ADDENDUM NO. 3

City of Chattanooga
Eastgate Family Justice Center
Derthick Henley & Wilkerson Architects

Date: 23 Sep 2015

Elevation E18 / A-402 (8 ½" x 11") Issued as part of this addendum.

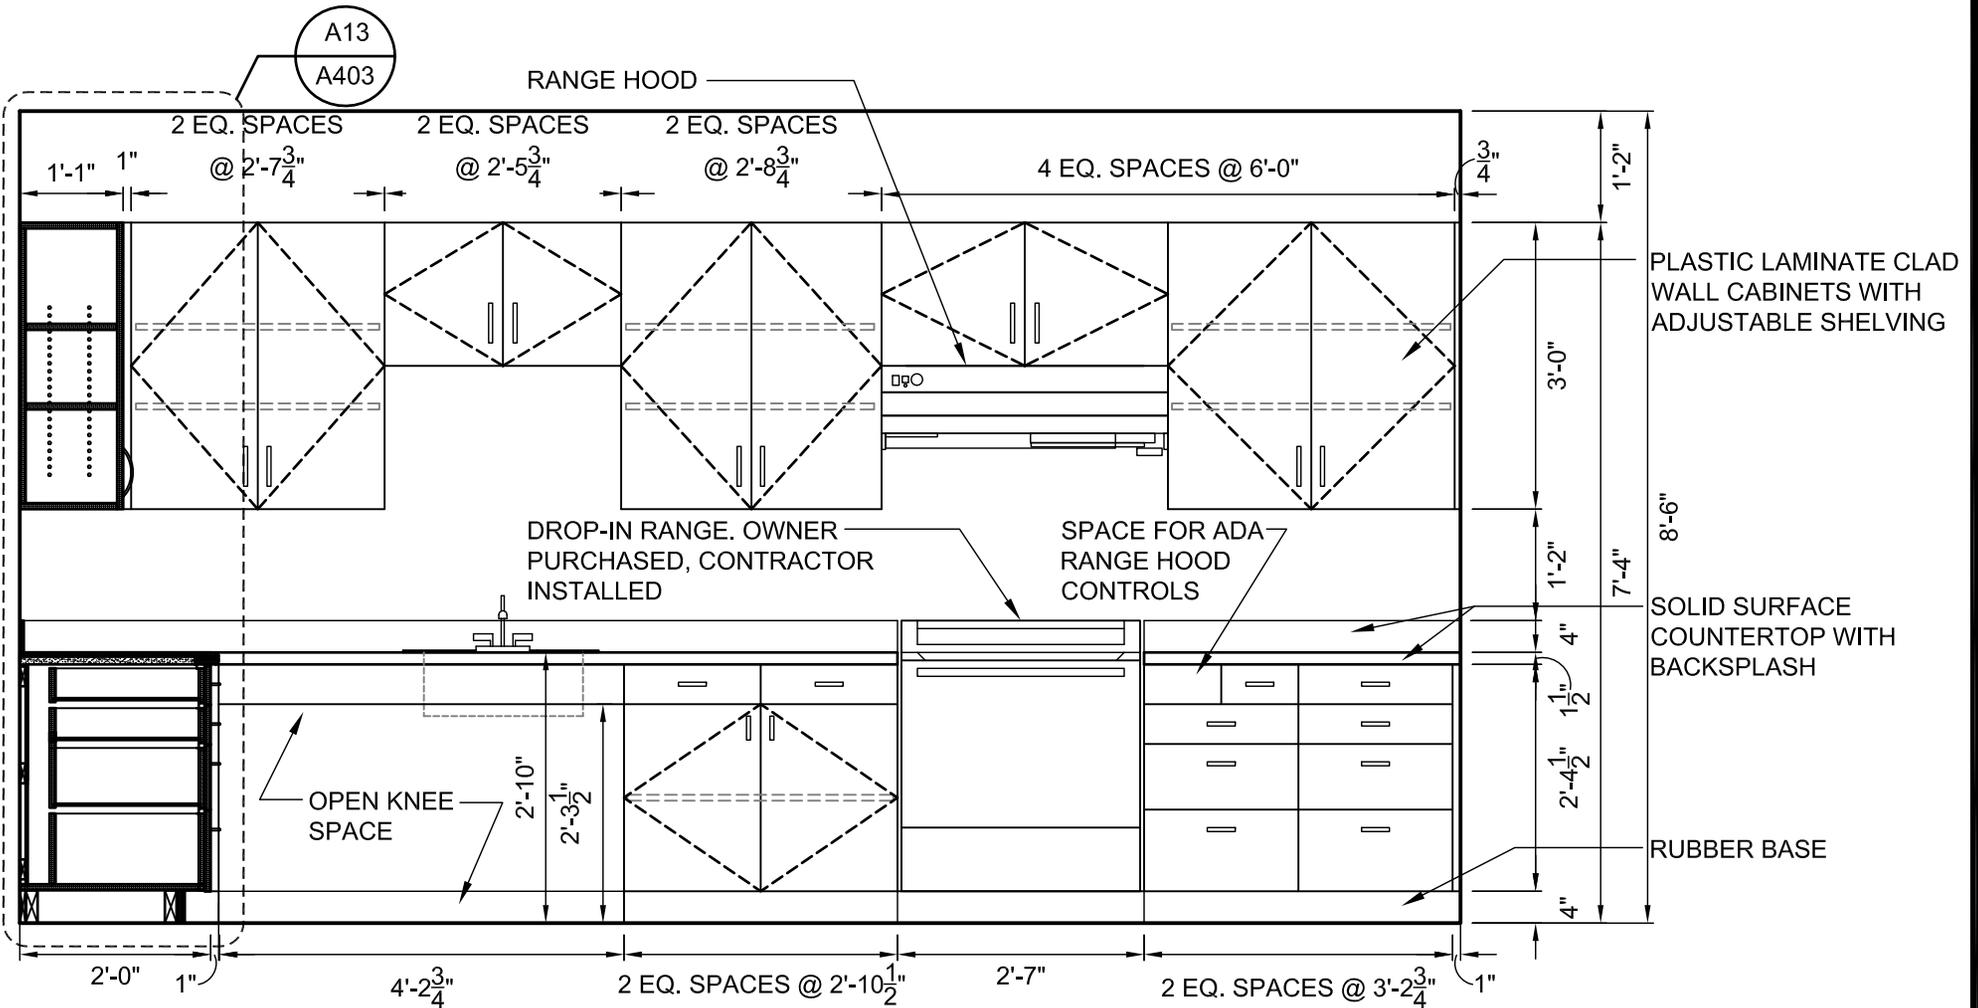
The open knee space at Client Kitchen A-106 is enlarged to provide adequate access and clearance per ANSI 117.1-2009.

NOTE:
 OPEN KNEE SPACE INDICATED IN ELEVATION COMPLIES WITH ANSI 117.1 - 2009 902.4 WITH COUNTERTOP HEIGHT AT 34".
 TOE CLEARANCE AND KNEE CLEARANCE COMPLIES WITH ANSI 117 - 2009 606.2 AND WITH CLEAR FLOOR SPACE COMPLYING WITH 305.3.
